## AMENDMENT TO THE DRAWINGS

## REMARKS

Respectfully submitted,  
Boaz JASCHEK, *et al.*  
DAVIS WRIGHT TREMAINE LLP

FIG. 1a

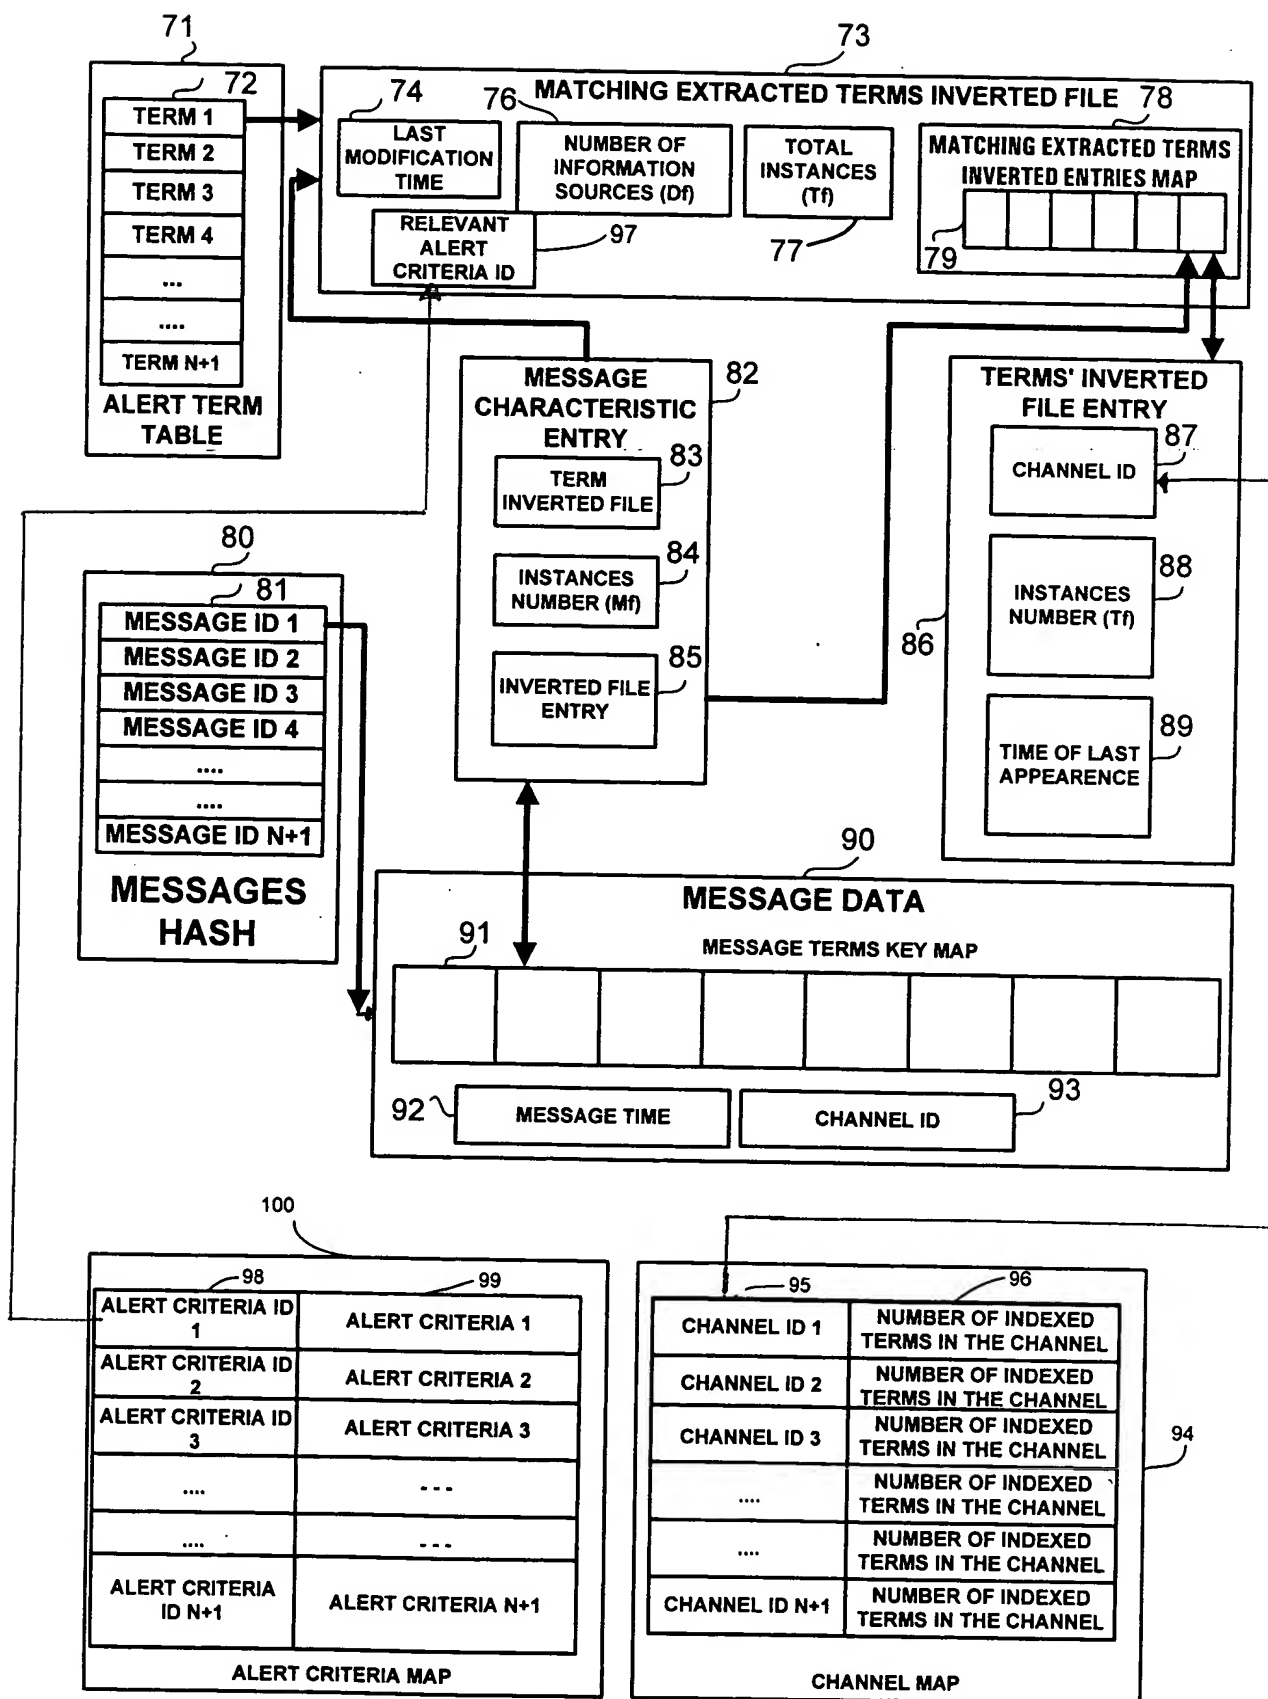
Figure 1a has been amended to add reference signs 4 and 5 described in the specification but inadvertently omitted in the figure. Figure 1a has also been amended to correct errors in the duplicative use of reference signs with respect to information retrieval data manager 20, agent 26 and classification system 24. "Information retrieval data manager 20" is now designated as "information retrieval data manager 23," "agent 26" is now designated as "agent 27" and "classification system 24" is now designated as "classification system 25". Amended figure 1a depicts the distribution means 4 to include: dispatcher 17, data builder 20, history manager 21, interfaces 13, 14, and 15, and client manager 18. Amended figure 1a also depicts the analysis means 5 to include: data manager 22, information retrieval data manager 23, alert module 3, search engine 26, query and alert manager 19, data retrieval management and prioritization 29, classification system 25, time zone unit 412, flow estimation unit 410, and relevancy determination unit 2.

Examiner objected to Figure 1a under 37 CFR 1.84(p)(5) because the figure does not include reference signs 4 and 5 mentioned in the description. Figure 1a has been amended to include reference signs 4 and 5. In light of the amended figure 1a, Applicants respectfully submit that figure 1a compiles with 37 CFR 1.84(p)(5), and respectfully request Examiner to withdraw this objection.

**ALERT MODULE**  
**FIG. 2**

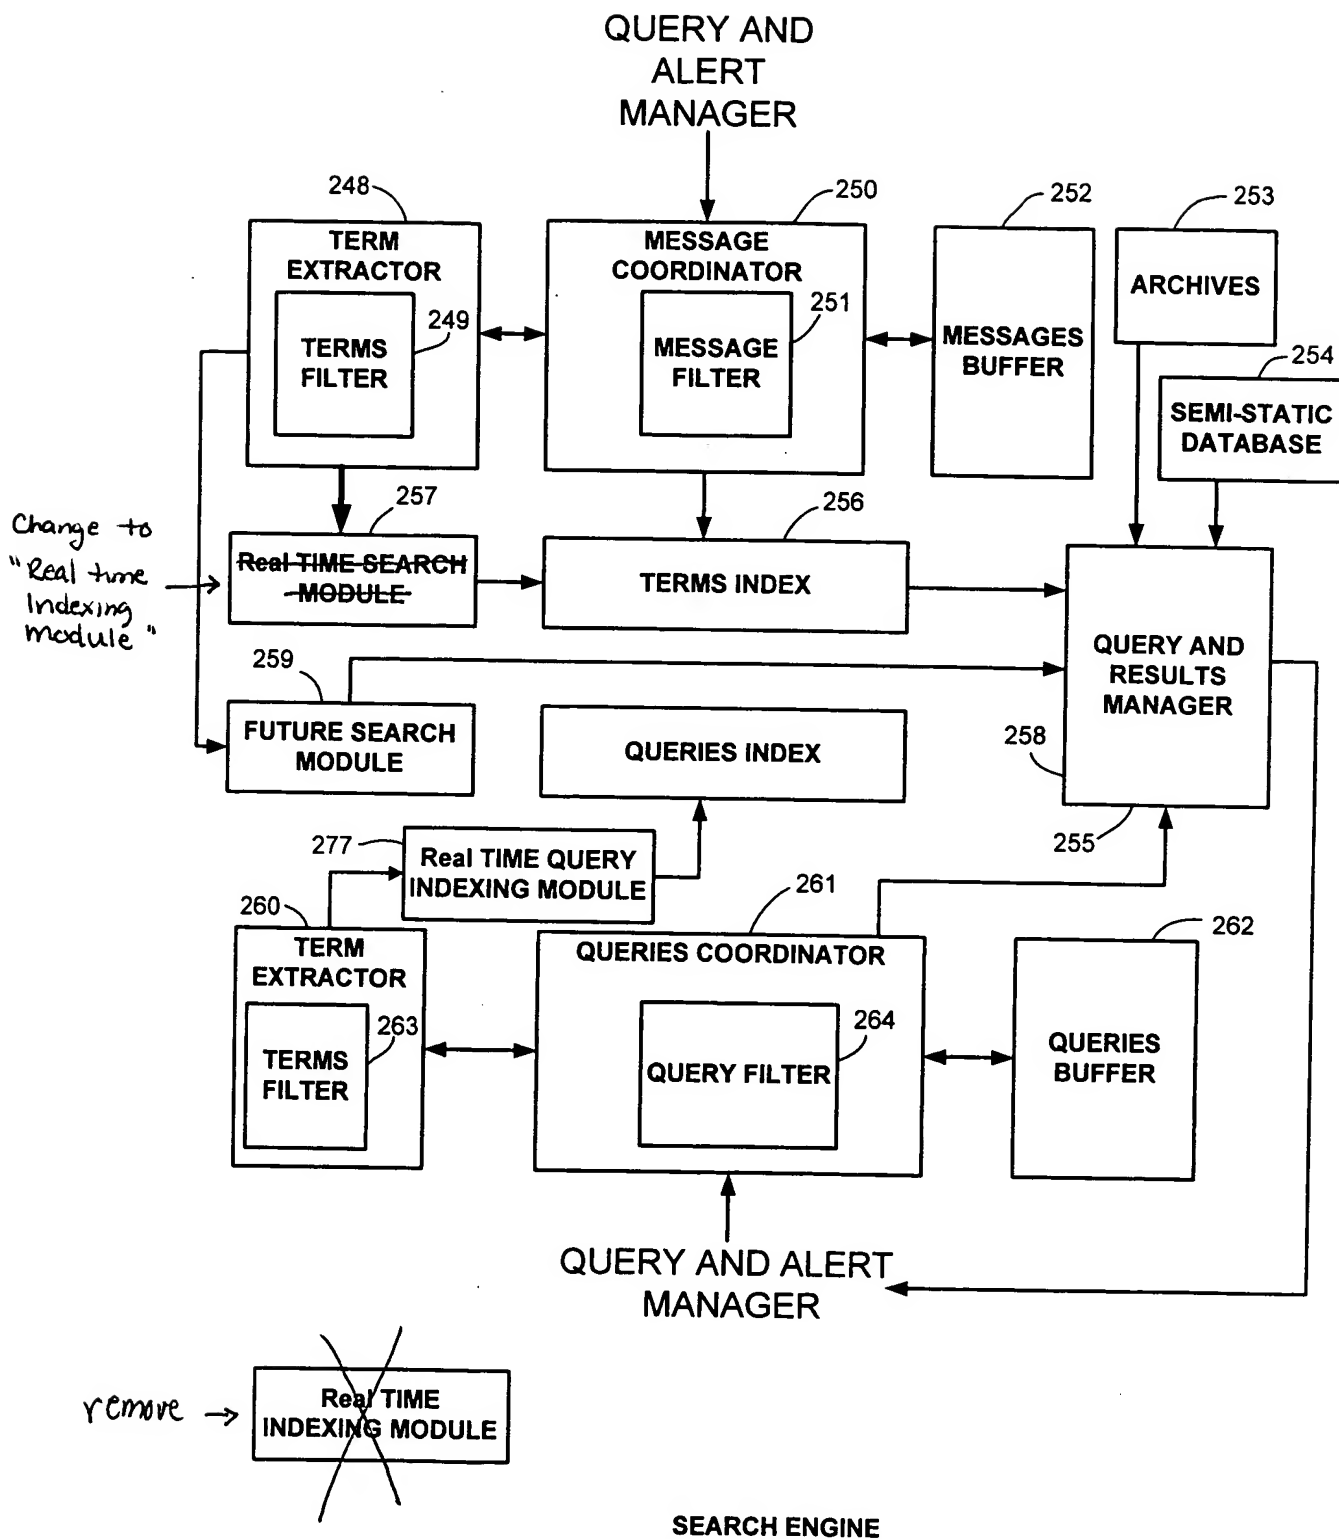
Figure 2 has been amended to remove "user 1" and "real time search module."
